UNITED STATES PATENT AND TRADEMARK OFFICE

APPLICATION NO.	FILING DATE	FIRST NAMED INVENTOR	ATTORNEY DOCKET NO.	CONFIRMATION NO.
10/723,126	11/25/2003	Donald R. Gilbreath	C02-085A	9442
26683 7590 03/30/2009 THE GATES CORPORATION IP LAW DEPT. 10-A3 1551 WEWATTA STREET DENVER, CO 80202				
EXAMINER DUNWOODY, AARON M				
ART UNIT		PAPER NUMBER		
3679				
MAIL DATE		DELIVERY MODE		
03/30/2009		PAPER

Office Action Summary

DETAILED ACTION

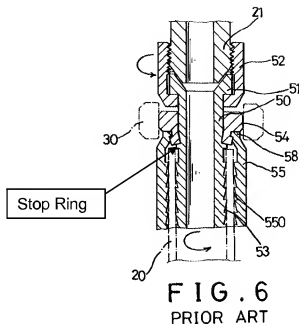
In regards to claims 1 and 2, Huang discloses an improved hydraulic fitting having a stem (50) including a hose insert portion (53), and a collar support portion, having a mating connection portion (50, 51), and a collar having (54), a torque communication portion, a female support portion, and an inner periphery extending through the ferrule support portion and the torque communication portion, the improvement comprising:

the collar support portion an axial stop ring (see Figure 6 below),

the torque communication portion of the collar staked in such a manner that the inner periphery extending through the torque communication portion communicates in a relatively non-rotational manner, and

the ferrule support portion of the collar staked in such a manner that the inner periphery extending through the ferrule support portion engages the axial stop ring in an axial movement limiting manner.

The original disclosure of the instant application and Huang are referring to the same low torque limit of the staking operation illustrated in Huang's Figure 6 above. The torque limit may be low, but it does resist low torques. Also, Huang clearly illustrates a stop ring in Figure 6 above. Therefore, Huang does not teach away from use of torque limiting feature with any axial stop ring, but discloses the use of low torque limiting feature with an axial stop ring, which meets the claim limitation.
